Technical Data Sheet

90-73213 Side Door Latch Upgrade

Heritage I 8021

Date: January 31, 2008

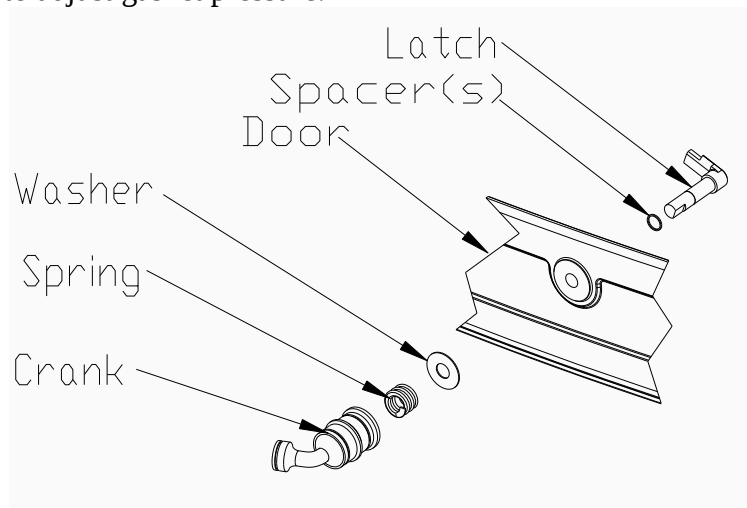
- 1) Remove and discard the old door latch assembly by loosening the setscrew with the allen wrench.
- 2) Install the new latch assembly as shown below. Start out with two brass spacer washers on the inside of the door. Thread the outer chrome crank (with the coil and large washer placed on the latch shaft as shown) onto the latch. Turn the crank until there is approximately 1/8" between the crank and the door.
- 3) Align the setscrew hole in the crank with the groove in the latch shaft and insert and tighten the set screw (the half dog tab will fit into the groove on the latch).
- 4) Check door seals using the "dollar bill test." Close the door on a dollar bill. If the bill pulls out without any resistance, then your stove's door is not sealing properly. Add or remove spacers to adjust gasket pressure.
